3.0 Design Statement

3.4 Form and Massing

7.0 Conclusion

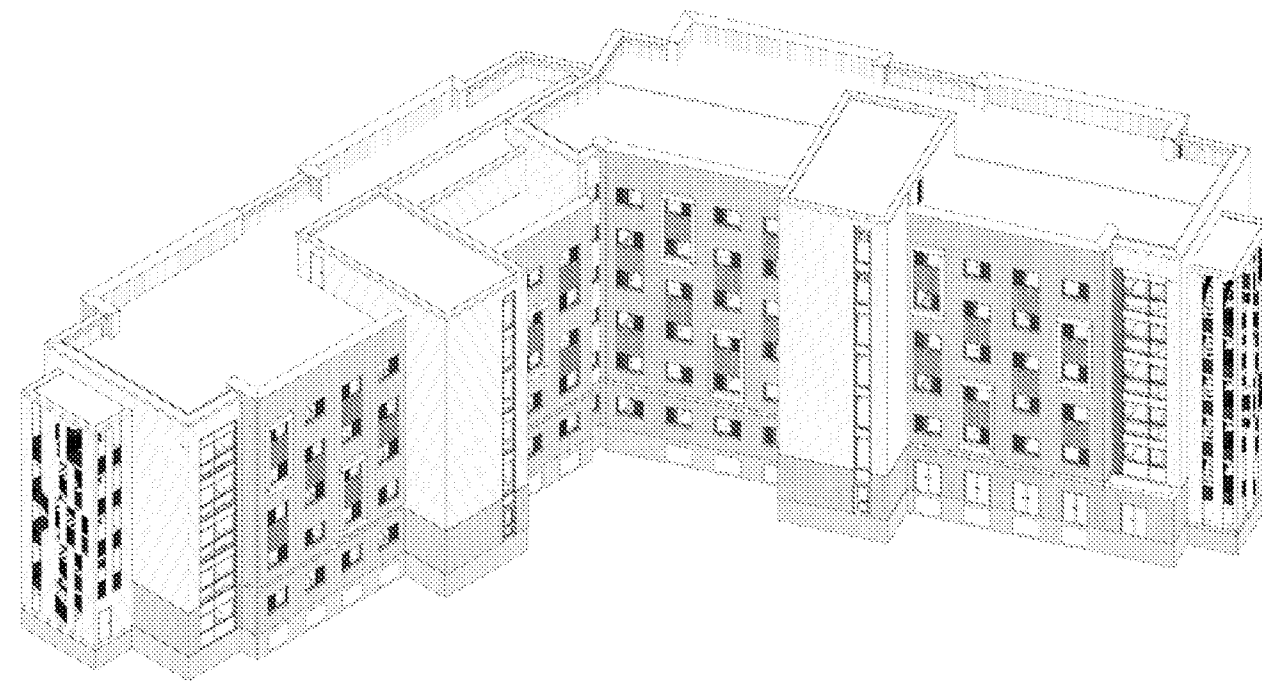
The changes to the layout described above have generated minor changes to the form and massing as follows:

- The reduction in number of cores, from two located halfway along each of the blocks, to a single core at the junction between the two blocks has enabled us to simplify the form and omit stair cores projecting into the central landscaped courtyard.
- The omission of the core to Block B has enabled us to also omit the link across the roof and the projection of this core up to roof level.
- The revised form is a simple interlocking of a 5 storey and 6 storey block
